AMENDMENTS TO THE DRAWINGS

REMARKS

FIG. 13

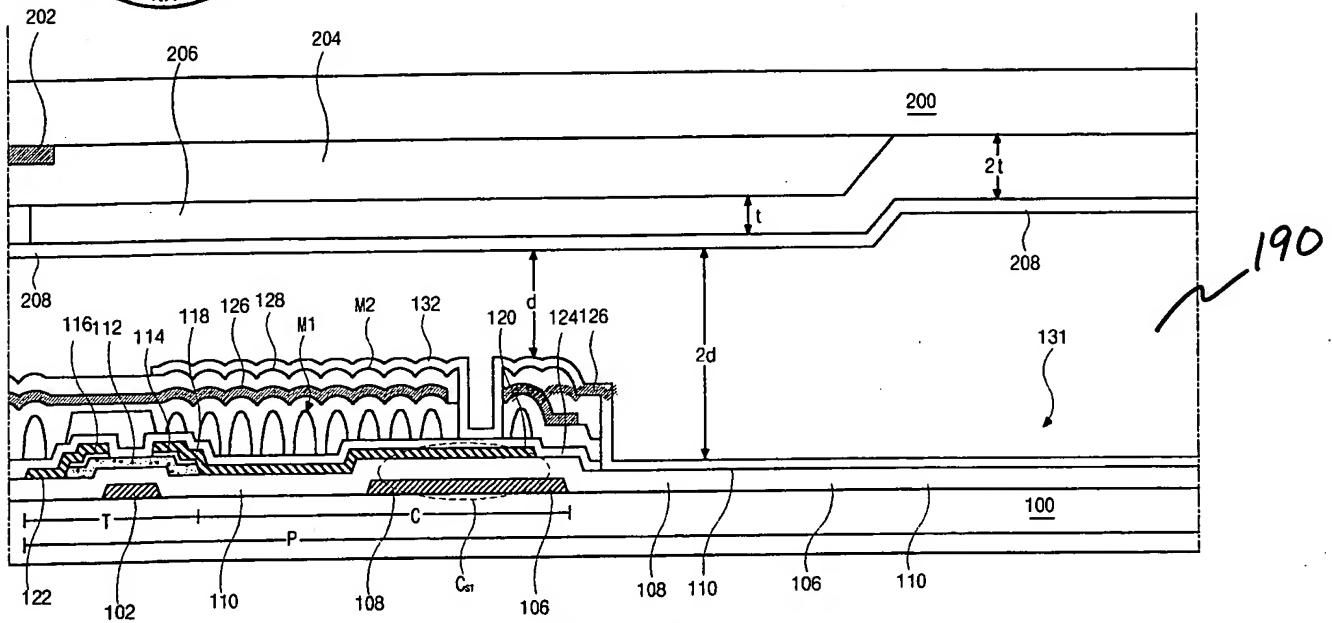
On page 2 of the Office Action (“Action”), the Examiner objects to Fig. 13 for failing to comply with 37 CFR 1.84(p)(5) because it does not include reference numeral “190” mentioned in the description. Figs. 13 and 14 have been amended to include reference numeral “190”, thereby addressing the Examiner’s concern.

The attached sheet of drawings includes changes to Figs 13 and 14. This sheet, which includes Figs. 13 and 14, replaces the original sheet including Figs. 13 and 14. The following changes have been made to Figs. 13 and 14, the reference numeral 190 has been added.
